Addendum to the Permanente Creek Flood Protection Project Final Subsequent Environmental Impact Report (SCH NO. 2007052074)

Project Number 26244001

May 2013

This Addendum is intended to address certain changes to the proposed activities associated with the future Permanente Creek Flood Protection Project, and amend the Final Subsequent Environmental Impact Report for the Project. This Addendum has been prepared to document proposed minor changes to the project design, to provide updated information about construction, and to evaluate the potential environmental impacts of those changes and new information. All proposed activities occur within the area defined by the original project (Figure 1). Details about the environmental setting can be found in the 2012 EIR cited above.

Figure 2 McKelvey Park Flood Detention Facility Design Modifications

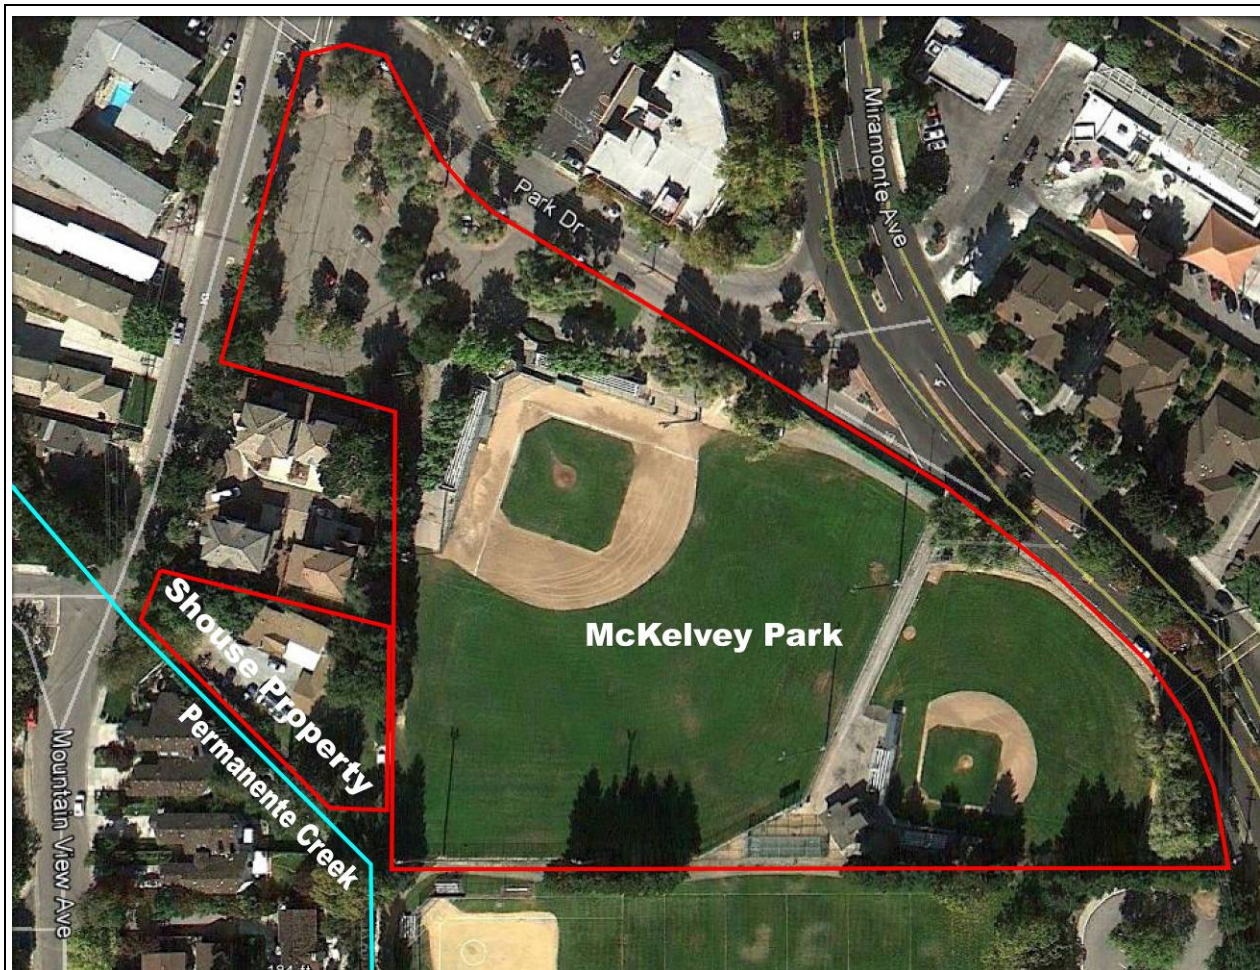
The District proposes to modify design of the McKelvey Park Flood Detention Facility. Consistent with city and community input, the large baseball field would be constructed with a southeast orientation as opposed to the northeast orientation of the adopted project. The revised field orientation would generally match the existing field position. Associated amenities that surround the field, including concession/scorers booth, restrooms, storage facility, meeting room, batting cage, viewer seating, and lighting, would be adjusted accordingly. Figure 2 depicts the proposed changes to the field design evaluated in the 2012 EIR.

Once cleared, the detention facility would be enlarged 0.2 acre to utilize the additional space provided by the Shouse property. The property would be excavated to a depth of about 15 feet with walls constructed of the same materials used to construct the sunken field. Dimensions of the proposed 200-linear-foot side channel proposed for the site would remain unchanged, but an access ramp would be constructed down the side channel to the bottom of the detention facility. Low flow pumps would be installed on the Shouse property rather than the northwestern corner of McKelvey Park. Construction equipment and techniques used to excavate the Shouse property and construct the access ramp would be identical to those included in the 2012 EIR. The overall detention facility construction schedule would remain unchanged.
